Technical Bulletin CS-3e RFI modification March 2010

Subject: Microphone CS-3e Serial Number Prior to #2792

Improve the physical ground connection and reduce exposure to Radio Frequency Interference

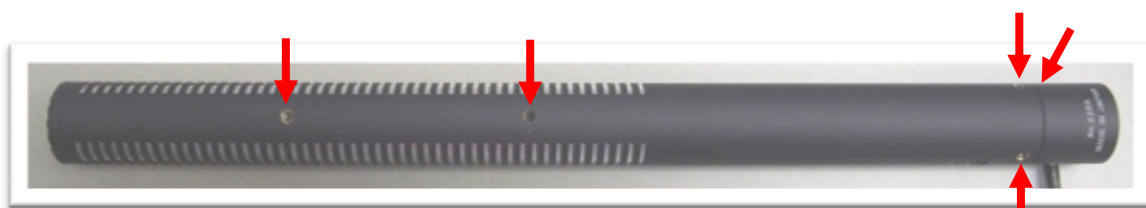
Remove the black paint on the inner part of the microphone connector shell as shown using sandpaper. This is to improve the electrical connection between the microphone and the cable plug connector shell.

Only remove the paint, not the black plating under the paint.

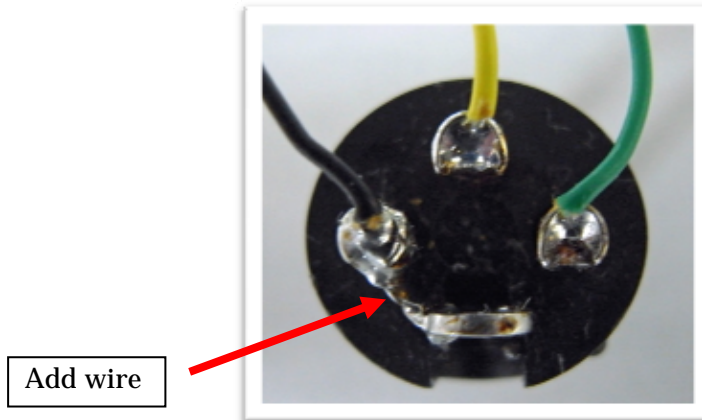
(f) Add wire from connector pin1 to shell terminal ground post.

Add wire

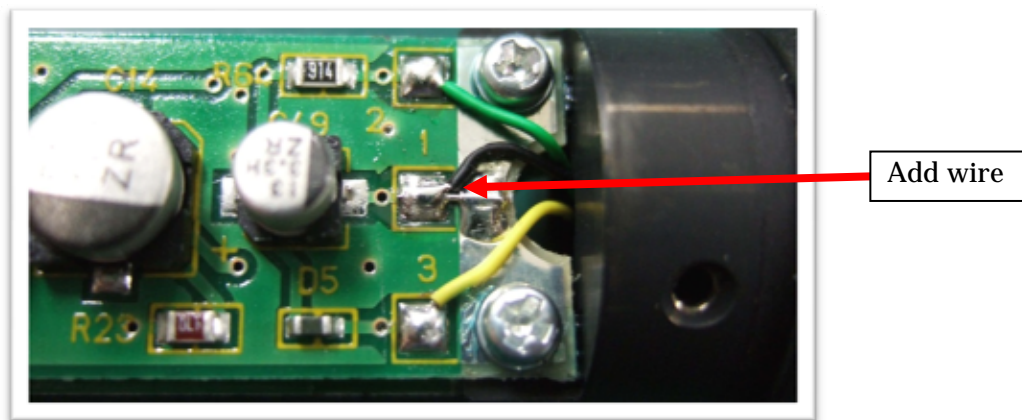
3. Add a short wire between the solder pad labeled "1" and the backplane ground solder pad.

Add wire
